Product Change Notice (PCN)

PCN Number: PCN-0451070R-01

Product(s) Affected: PJ-028-SMT-TR, PJ-071, PJ-029-SMT-TR

Right

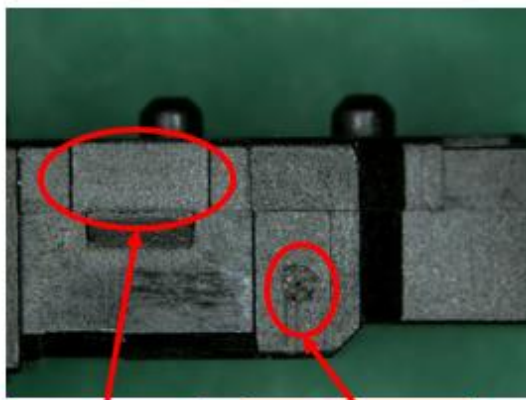
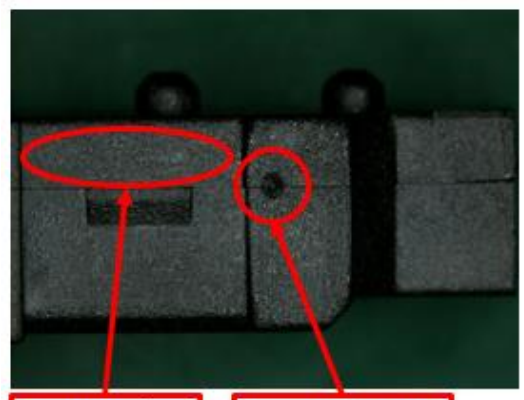
with mark

injection point

no mark

injection point

Top

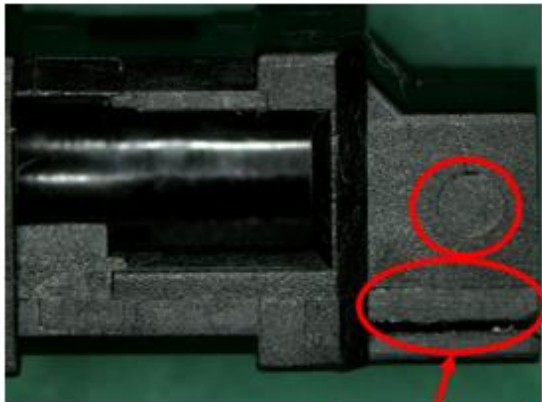
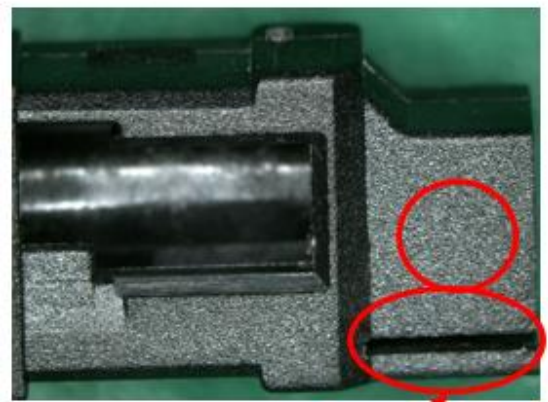
with mark

no mark

Bottom

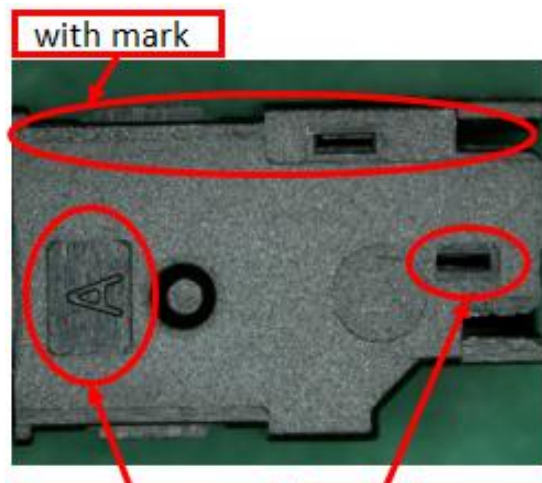
with mark

outlook different

mark position

no mark

outlook different

mark position
